26-H110 - CNSC Staff Submission

Request for Authorization of changes to the Lutetium-177 (Lu-177) production process at Bruce Nuclear Generating Stations A & B

Classification	UNCLASSIFIED
CMD Type	Original
CMD Number	26-H110
Reference CMD(s)	N/A
Type of CMD	Request for Authorization
Hearing	Hearing in writing based solely on written submissions
Date of Hearing	June 2026
Summary	This CMD presents information about the following matters of regulatory interest with respect to Bruce Power's Request for Authorization of changes to the Lutetium-177 (Lu-177) production process at Bruce Nuclear Generating Stations A & B
Sommaire	Ce CMD présente de l'information sur les questions d'ordre réglementaire suivantes concernant : Demande d'autorisation de modifications au procédé de production de lutécium (Lu-177) aux centrales nucléaires de Bruce A et B

Figure 2. Overview of the proposed hot cell design [4].

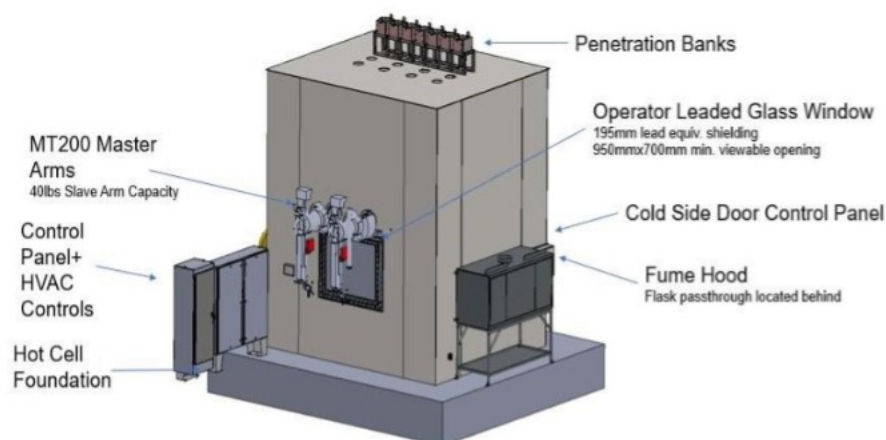
In support of the proposed process modification involving the hot cell, Bruce Power has submitted an overview for the design, a Generic Final Safety Analysis Report, CMF Fire Hazard Assessment Code Compliance Review and Event Identification and Classification Report, CMF Radiological Consequences of Bounding Events, Worker Dose Assessment and notification of Program/Procedure for CNSC staff review.

Figure 3. Lu-177 target assembly overview [4].

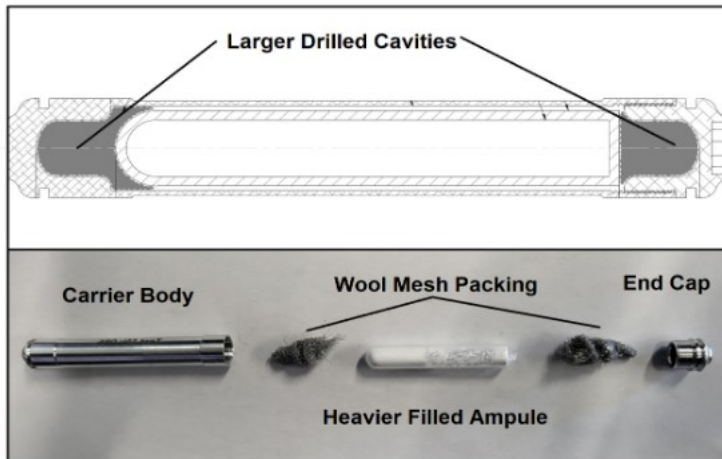
CNSC staff also acknowledged that Bruce Power is in the process of modifying the Isotope Production System (IPS) target carrier assembly [15]. Bruce Power is proposing a target carrier material change to modify the target design by replacing the aluminum with high-purity titanium. This proposed change is not part of the scope of the present CMD and is currently subject to CNSC staff review pursuant to the Power Reactor Operating Licence PROL 18.04/2028, Licence Condition G.2, and the Licence Conditions Handbook LCH-PR-18.04/2028-R005, Section G.2 and 5.1. CNSC staff have assessed Bruce Power's request across the waste management SCA and have confirmed that Bruce Power's programs, as referenced in the request, are adequate and able to support the proposed modifications to the Lu-177 production process. CNSC staff's assessment is based on the currently approved material configuration. However, a preliminary review of the changes to the target carrier material has shown that the target carriers will be much less radioactive following removal of the targets. This is expected to shorten the duration waste is to be stored prior to release and as such will reduce the inventory of material stored in the hot cell for decay.
